CALIFORNIA REGIONAL WATER QUALITY CONTROL BOARD
LAHONTAN REGION

BOARD ORDER NO. R6V-2010-0047-A1
WDID NO. 6B362098001

AMENDED REVISED WASTE DISCHARGE REQUIREMENTS

MOLYCORP MINERALS MP MINE OPERATIONS LLC
MOUNTAIN PASS MINE AND MILL OPERATIONS

Attachment A (Revised December 2025) Mine Site NWTDF and Existing/Expansion Overburden Waste Pile

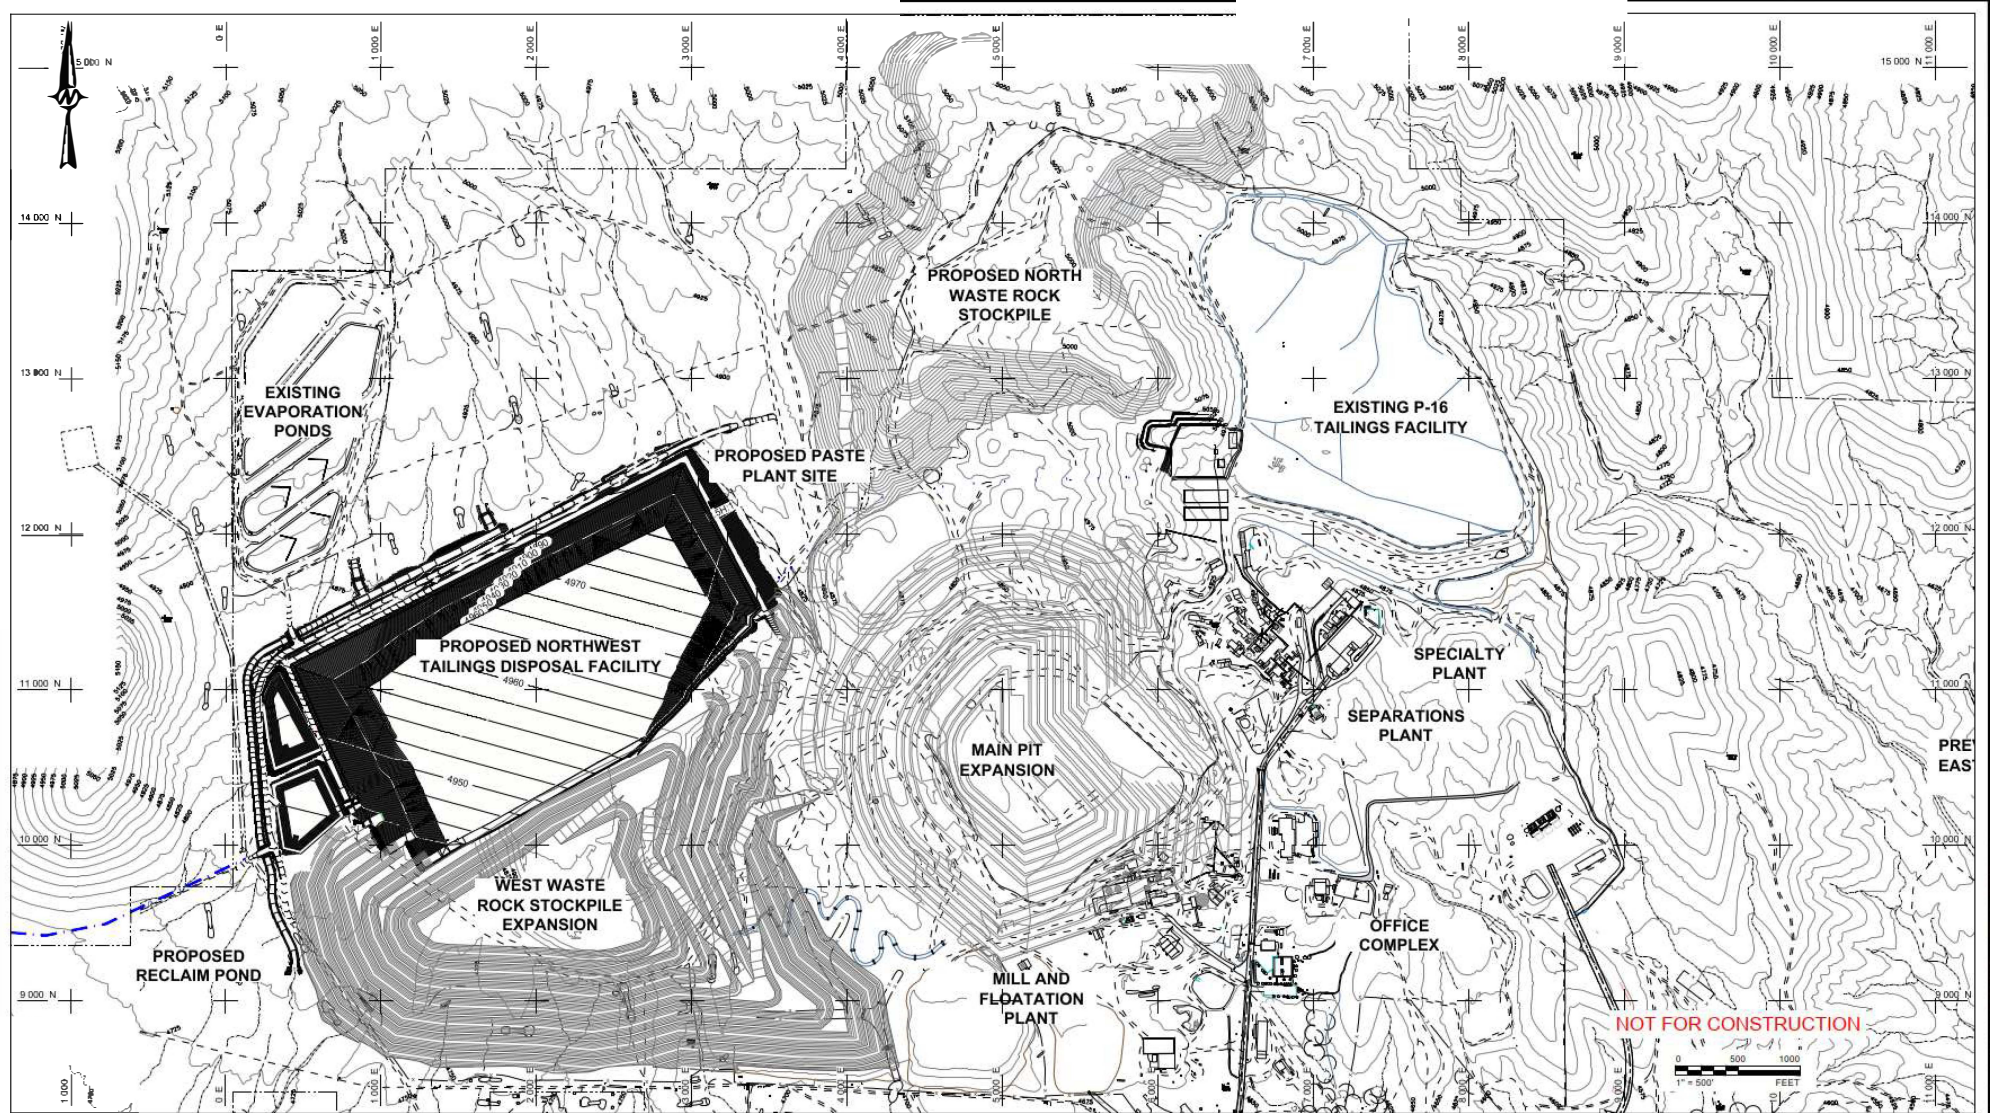
- Attachments:
- A. Mine Site ~~Proposed~~ NWTDF and Existing/Expansion Overburden Waste Piles
 - B. Characteristics of Paste Tailings Waste (Tailings Solids)
 - C. ~~Proposed~~ NWTDF Stage 1 Lined Area, Reclaim/Clarification Surface Impoundments
 - D. Proposed NWTDF Slope – Liner Design
 - E. Unsaturated Zone Monitoring Design
 - F. Clarification Pond Liner Design
 - G. Mine Site Map – Surface Impoundments Closure Status
 - H. Status of Surface Impoundments - Closure
 - I. Standard Provisions for Waste Discharge Requirements
